STAFF REPORT 5/11/2022

SUBJECT: Tripoli Mixed-Use Project

SPECIFICS: Adopt Ordinance No. 1193 and Resolution No. 2022-48 approving Change of Zone (CZ) 22-01, Conditional Use Permit (CUP) 351, Architectural Review (AR) 22-04 to amend the Official Zoning Map by adding the PUD (Planned Unit Development) Overlay Zone on 2.8 acres of vacant C-G (General Commercial) zoned property for a mixed-use development consisting of 108 apartment units and 2 retail units. The site is located at the northeast corner of Cesar Chavez Street and Bagdad Avenue (APN# 778-081-003 and -001) Applicant: Chelsea Investment Corporation

Figure 2: Site Plan

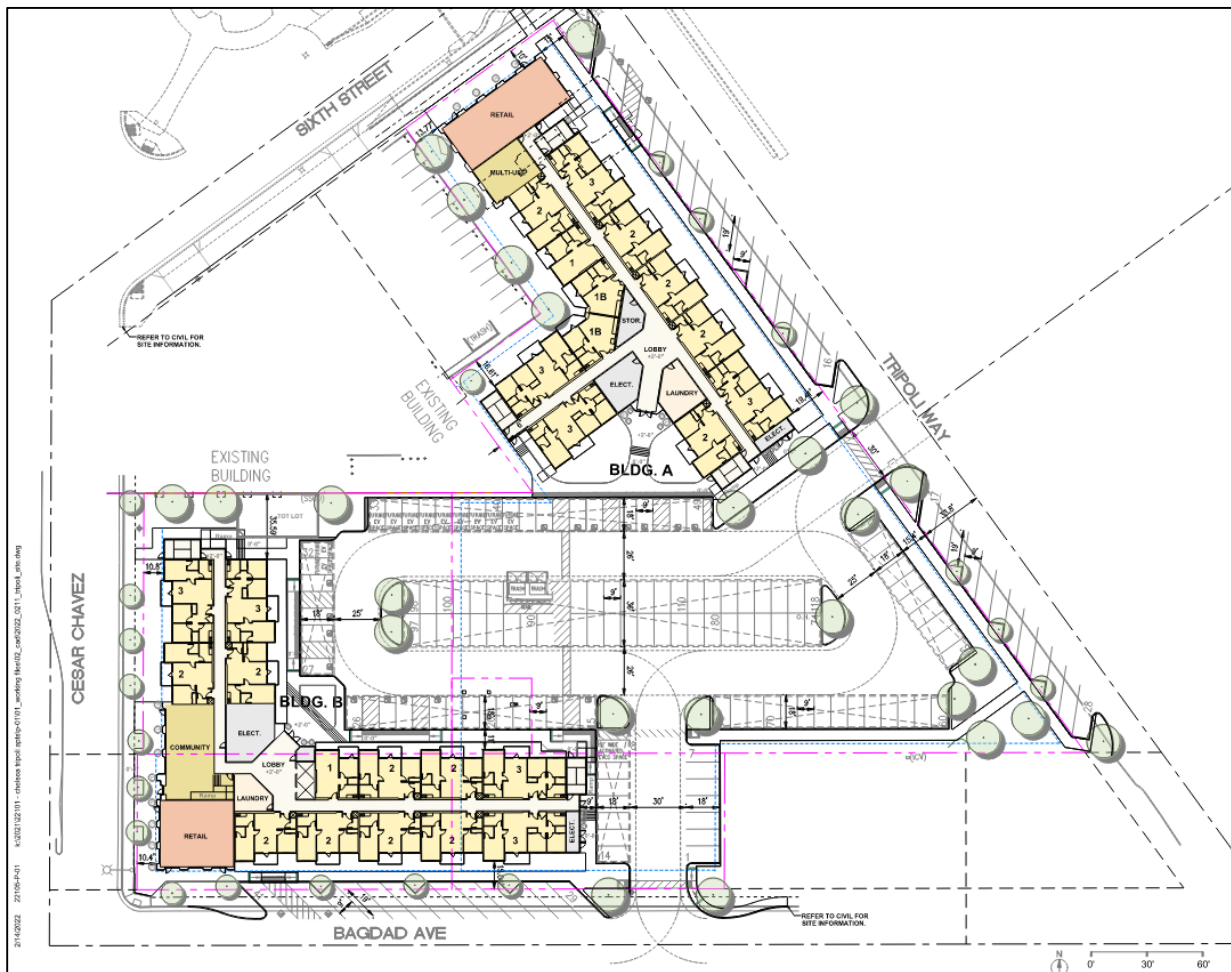
A 652 sq. ft. multi-purpose building and laundry room is proposed on the first floor. The main entrance and lobby is accessed from the parking lot, in addition to 3 other access points. Access above the first floor is by three proposed staircases and no elevator is proposed. Staff has requested that space between the west building elevation and property line be configured to improve safety and opportunity for usable common area for residents and customers of the retail space.

Ground floor retail for Building A and B would not include improvements such as bathrooms, fire sprinklers, or grease traps. The Pueblo Viejo Draft Standards require 15 foot high ceiling for ground floor retail to accommodate modern commercial and retail activities. The applicant has stated that the retail ceiling is 12 feet in height.

A 218 sq. ft. fenced tot lot is proposed near the project parking lot with playground equipment for children. No details of the playground equipment were submitted for the Architectural Review, but will be reviewed during building permit plan check. The project does not provide a significant amount of common outdoor open space for the project, but does contribute to an attractive and high quality streetscape as recommended in the Pueblo Viejo Revitalization Plan.

The parking serving the site is provided with one large on-site parking area consisting of 118 parking spaces and is accessed by driveways from Bagdad Avenue and Tripoli Way. Parking based on 120,873 sq. ft. of gross floor area, would require 362 spaces in the Pueblo Viejo Revitalization Plan. The applicant proposes 118 onsite parking spaces and 41 on-street parking
